Intersection ID: 10654	Main Street: E_35TH_ST	Cross Street: WESLEY_AV	Location:	N
ADA ID: 98B243875107	Ramp Type: PerpDiag	Initial Pass/Fail: Fail	Overall Compliance: No	Severity Score: 13.75

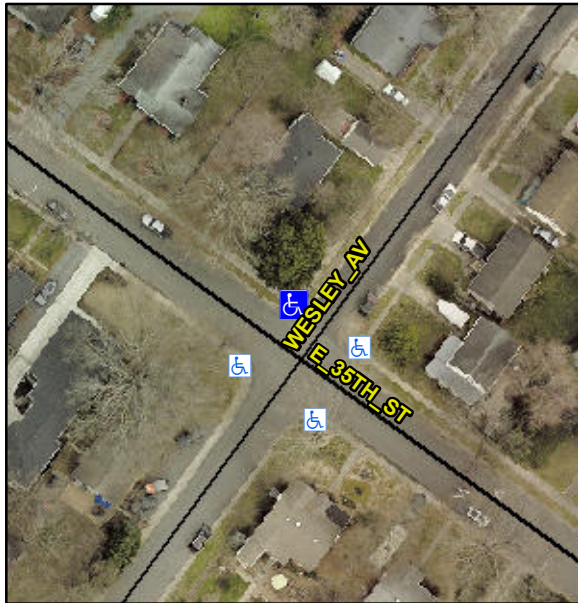
Not Found, R304.2.2, R304.5.3

Compliance	Description	Data	Compliance	Description	Data
N/A	Ramp Length (in)	27.0	No	Ramp Slope (%)	10.5
Yes	Ramp Width (in)	48.0	No	Ramp XSlope (%)	2.6
N/A	Flare Type LT	N/A	N/A	Flare Type RT	N/A
N/A	Flare Slope LT (%)	N/A	N/A	Flare Slope RT (%)	N/A
N/A	Flare Traversable LT?	N/A	N/A	Flare Traversable RT?	N/A
N/A	Landing Length (in)	N/A	N/A	DWS Provided?	N/A
N/A	Landing Width (in)	N/A	N/A	DWS Contrast?	N/A
N/A	Landing Slope (%)	N/A	N/A	DWS Length (in)	N/A
N/A	Landing X Slope (%)	N/A	N/A	DWS Full Width?	N/A
N/A	Landing Curb? (Y/N)	N/A	N/A	DWS Offset (in)	N/A
N/A	Shared Landing?	N/A			
N/A	Gutter Ponding?	N/A	N/A	Gutter Slope (%)	N/A
N/A	Gutter Lip Ht (in)	N/A	N/A	Gutter X Slope (%)	N/A
N/A	Painted X Walk1?	No	N/A	Painted X Walk2?	No
	X Walk 1 Direction	To SW		X Walk 2 Direction	To SE
N/A	X Walk 1 Width (in)	N/A	N/A	X Walk 2 Width (in)	N/A
	X Walk 1 Slope (%)	3.8		X Walk 2 Slope (%)	1.9
	X Walk 1 X Slope (%)	2.0		X Walk 2 X Slope (%)	1.0

Remove & Replace Curb Ramp With Two New Directional Ramps or Equivalent.
